Greg Lewicki and Associates, PLLC

June 30, 2015

✓ **RE: Revenue Mine, Permit M-2012-032, Amendment AM-1
Adequacy Review #1 Response**

Map C-4: Phase 3 Mining Extents
Revenue Mine
Fortune Revenue Silver Mines, Inc.
M-2012-032 AM01
Adequacy Review #1 Response

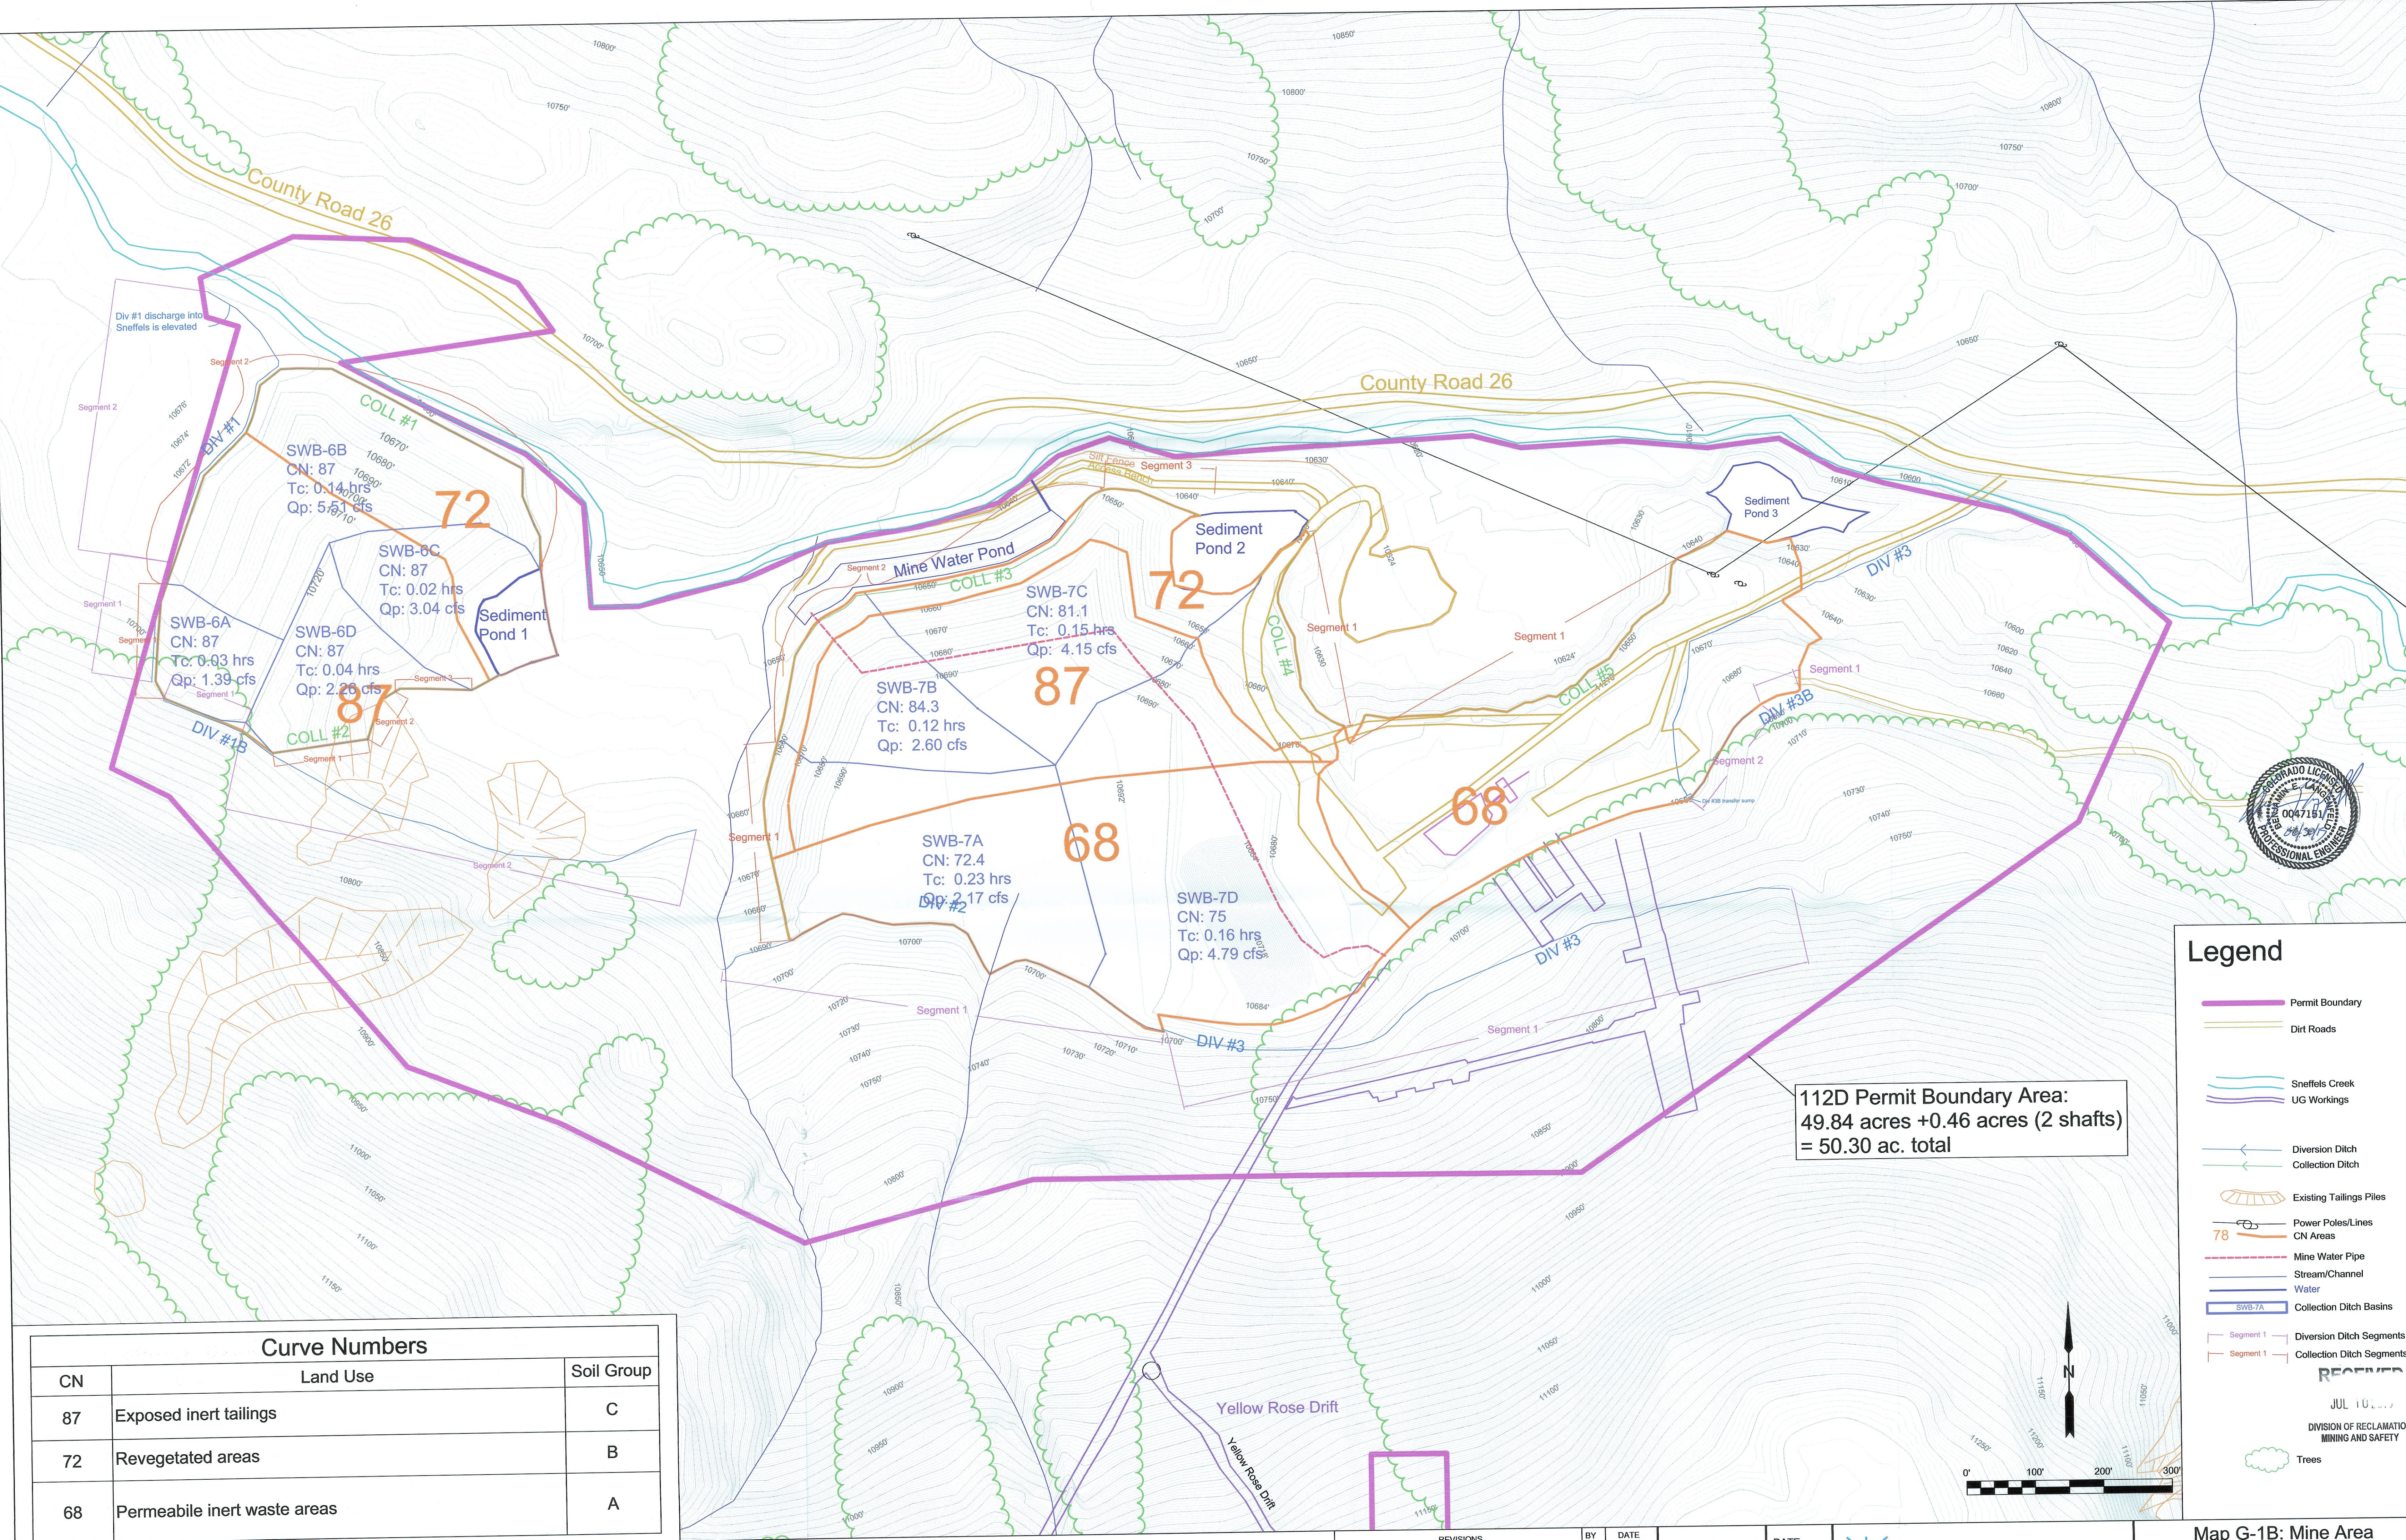
- 2. Please provide more information about these features that appear on the Revenue Mine area maps (such as Map C-4, for example): the "potentially contaminated concrete lined tailings storage area" near the thickener, and the "temporary wet tailings storage area (unlined)" behind the dry building.**

50. The narrative on page T-28 states that the avalanche path is shown on the Exhibit C maps, but the path is not shown on those maps.

Please see the revised Maps C-2, C-3, and C-4.

**Map G-1B: Mine Area
Surface Hydrology
Revenue Mine
Fortune Revenue Silver Mines, Inc.**
M-2012-032 AM01
Adequacy Review #1 Response

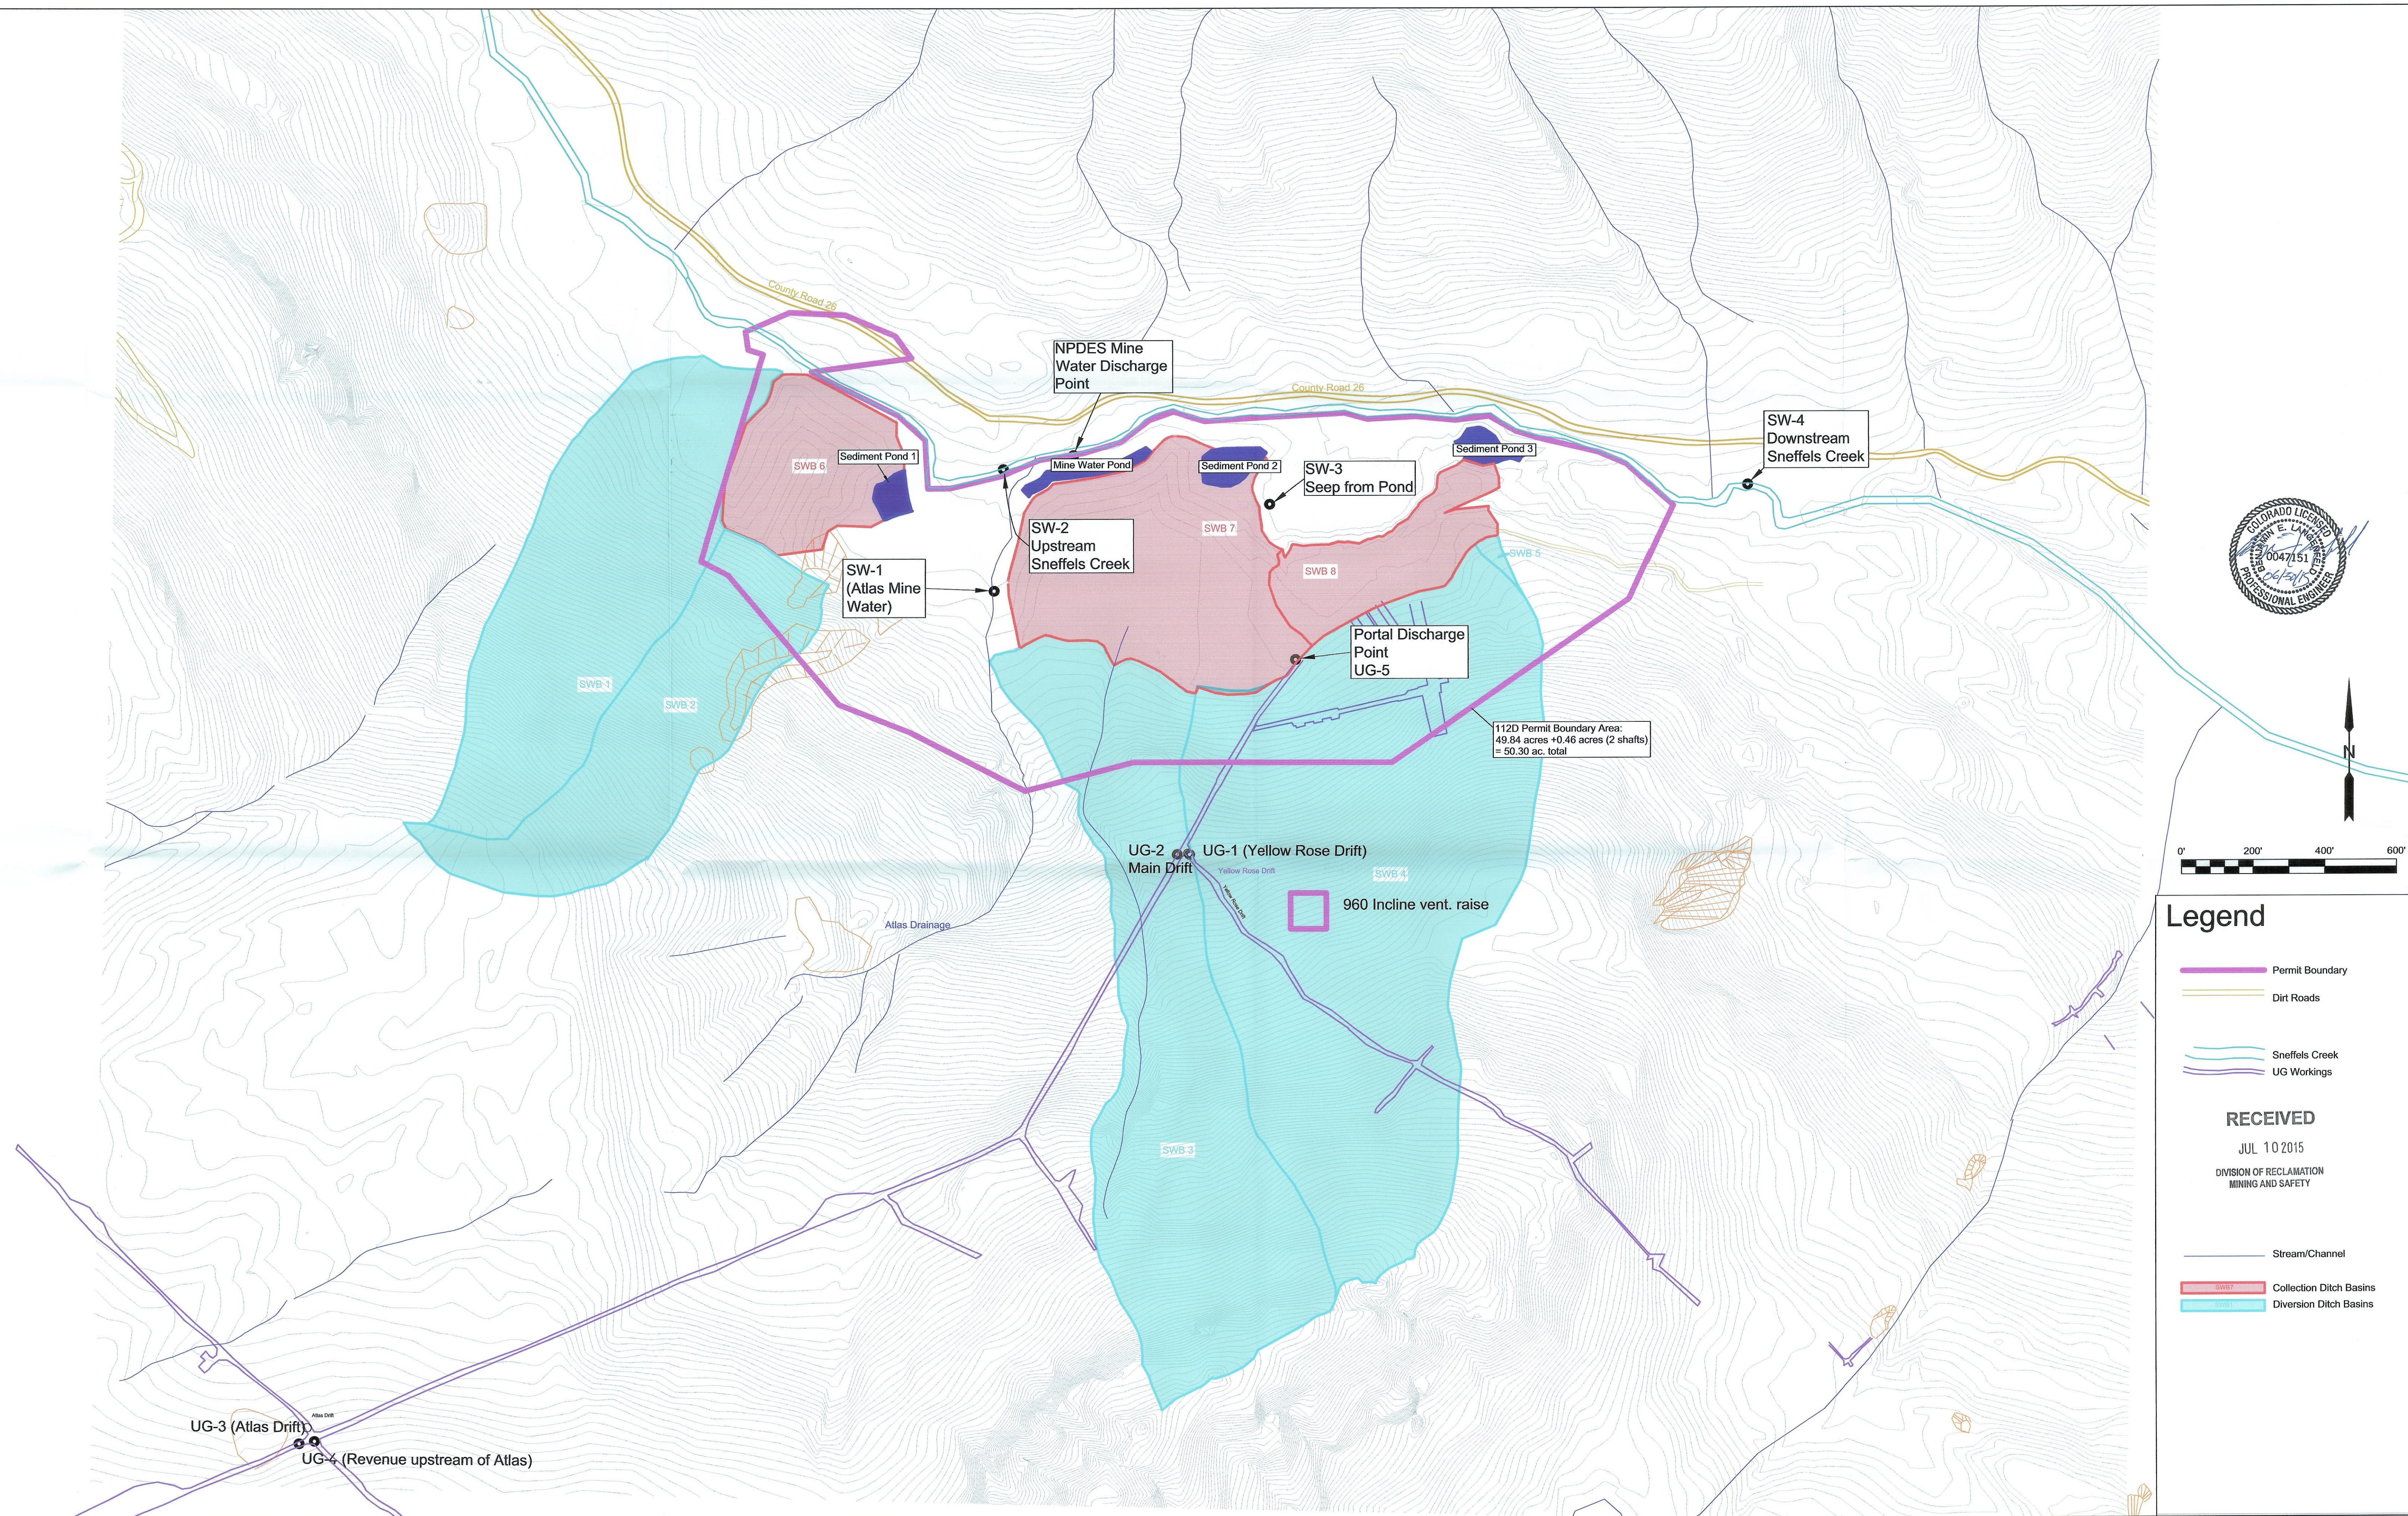
- 32. Map G-1B does not show an inlet pipe delivering water to the mine pond.**

- 33. Map G-1B does not show the upland diversion ditch above the Revenue Mine portal and filter building in the proper location, as it appears to be too low on the slope.**

See revised Map G-1B.

The upland diversion ditch above the Revenue Mine portal now shows the current location.
